## Requirements for Generators Art 13 (4) and (5): Recommendations

November 2017

## General

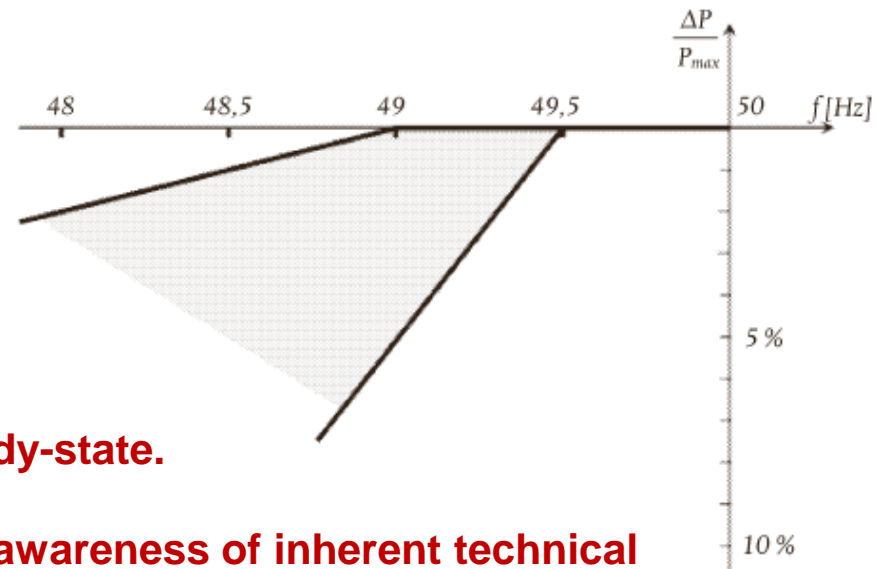
**No requirement to dynamic behaviour.**

**The requirement can be interpreted as steady-state.**

**Art 13 (5) has been introduced to RfG after awareness of inherent technical constraints of some relevant technologies: equal to or prevailing Art 13 (4)!**

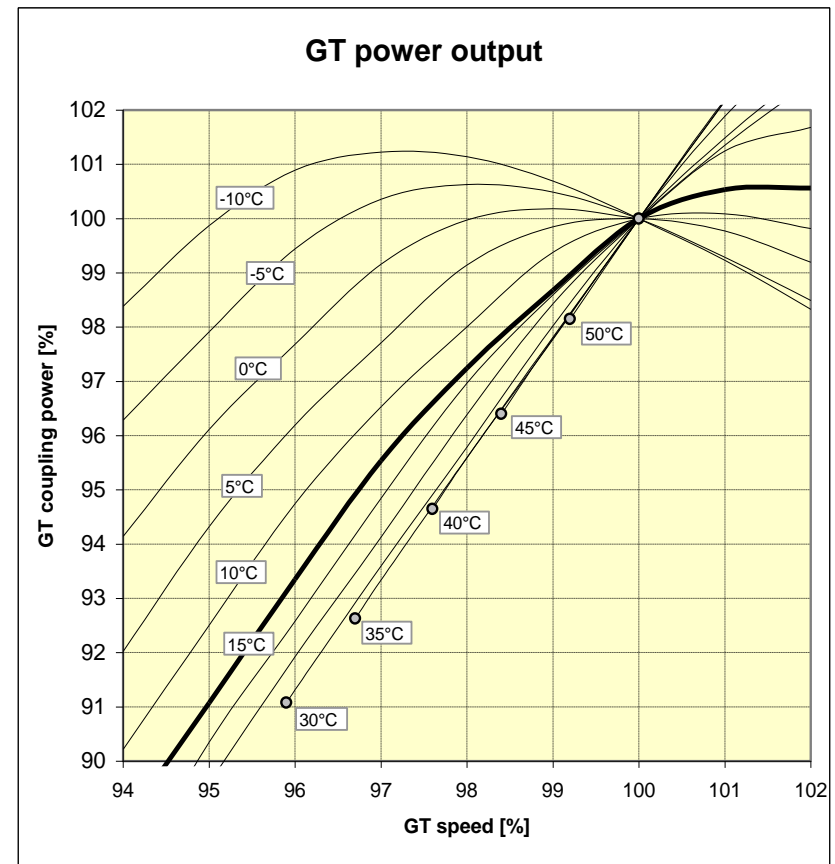
- Gas turbines output is influenced by different external factors. Depending on ambient conditions, power drop exceeds allowed values in Art 13 figure 2.
- Principle steady-state behaviour is shown in att. figure (values are only indicative!)
- Dynamic behaviour is worse since compensating power control loops need time to react to frequency drop (if reserve is available)

**Technical and ambient limitations to be considered in requirement !**
